<b>Tech. Information No.</b>	2096 / 2017
<b>Subject:</b>	IPP-MAP0005-2 MAP Power Supply, 150W

<b>Short Description:</b>	[EN] MAP Power Supply – Restriction for Firmware Update [DE] MAP Netzteil – Einschränkung für Firmware Aktualisierung
---------------------------	--

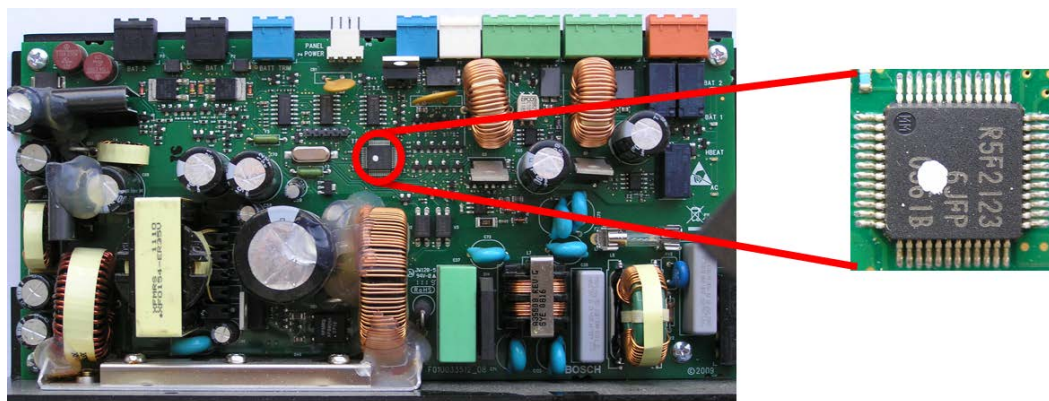
[EN] Firmware update of the MAP power supply has been provided since system bundle 1.43.2. Before you start a firmware update, please check whether the device is suitable for a firmware update according to the table below.

FW update not possible
CTN at device label	IPP-MAP0005
CPU Color marking	white
Current FW version	v1.01 or lower

The power supply is NOT suitable for a firmware update if at least one characteristic is true.

Attention: The attempt of a firmware update on an unsuitable device will result in permanent damage of the power supply.
